SUBJECT: ROCKWELL HANFORD OPERATIONS DOCUMENT SD-BWI-TI-109,
"... HYDRAULIC TESTING OF MIDDLE SENTINEL BLUFFS..."

WASTE MANAGEMENT DOCUMENT REVIEW

DOCUMENT: Preliminary Results of Hydraulic Testing of the Middle Sentinel Bluffs Basalt Colonnade/Entablature (3175-3244) feet at Borehole RRL-2, Rockwell Hanford Operations (RHO), SD-BWI-TI-109, released January 1983.

Figure 1. Flowrate vs. transmissivity for each step.
 TI-109 Cohasset Interior
 4 Step Injection Test

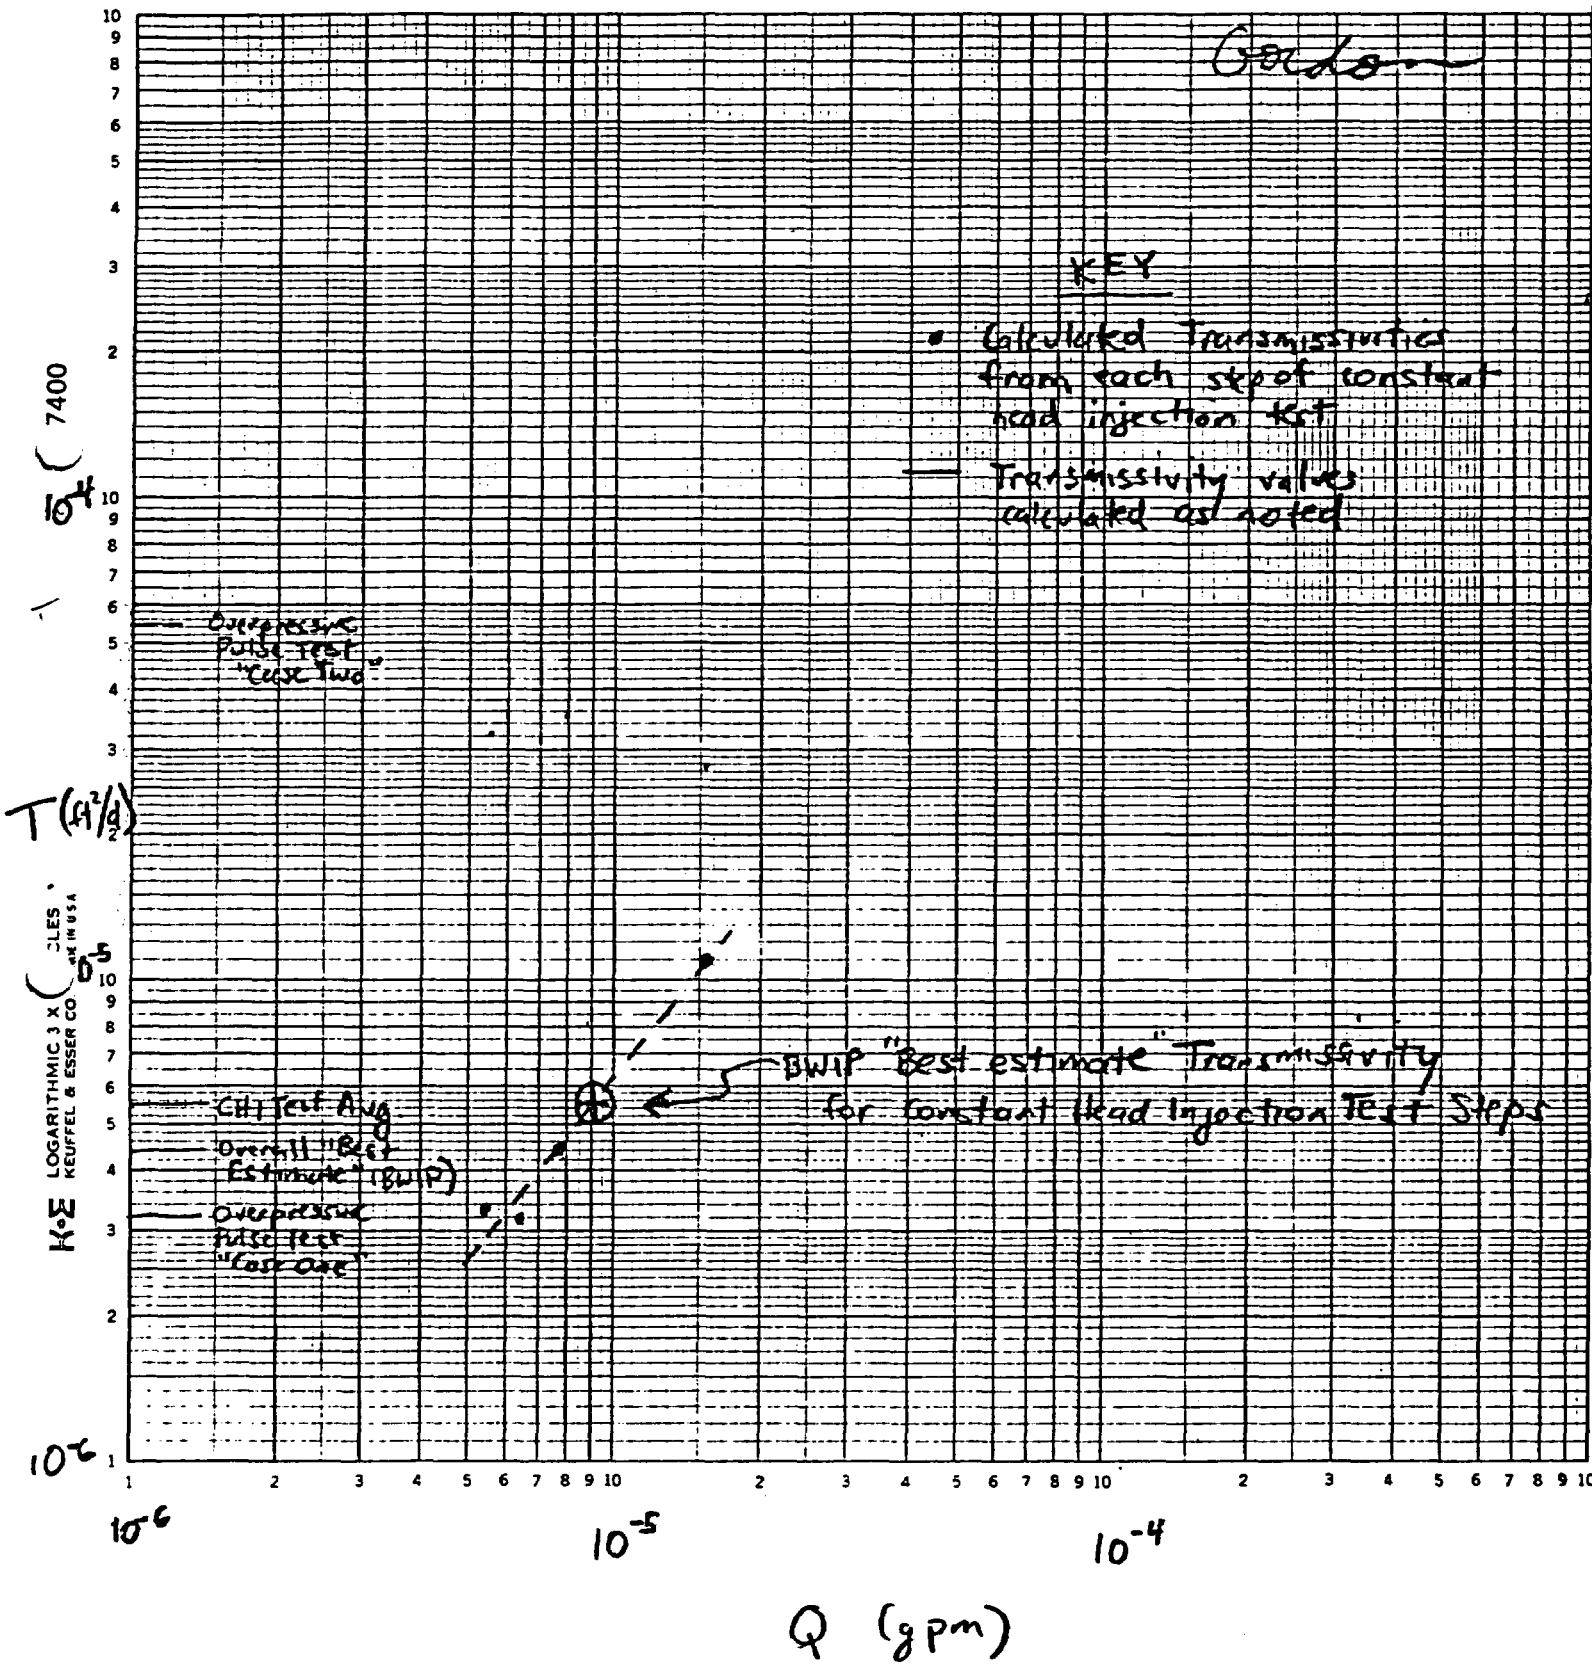
BWIP does not indicate the temperature of injected fluid; this could make their estimates of imposed heads erroneous, as NRC has pointed out in reference to other tests at BWIP (c.f., Wright to Olson, May 25, 1984). Regardless of this point, however, the results presented by BWIP in Table 2 of the subject report (attached) indicate substantial irregularities in these tests. Figure 1 shows the calculated transmissivities as a function of the steady-state flow rates for each step. These should theoretically plot along a straight horizontal line. Figure 2 shows the steady flow rate as a function of the imposed head. This should plot as a straight line of positive slope with flow (Q)=0 intercept at imposed head (H)=0. However, this is not the case for the BWIP tests. For example, the BWIP tests indicate that the lowest head imposition required the highest flow rate to maintain, which is contrary to the theoretical response. The only portion of the plot which even has positive slope is section B; however, this section has a Q-intercept (H=0) at $-1.56e-5$ gpm, rather than zero.

BWIP uses the arithmetic mean transmissivity value calculated by these four tests to get a best estimate for the constant head injection tests. It is not clear why they did not use the highest (most conservative) value as their best estimate as they have done occasionally in other interval reports. The high value ($1.1e-5$ ft²/d) is twice the assigned best estimate ($5.5e-6$ ft²/d) for these tests.
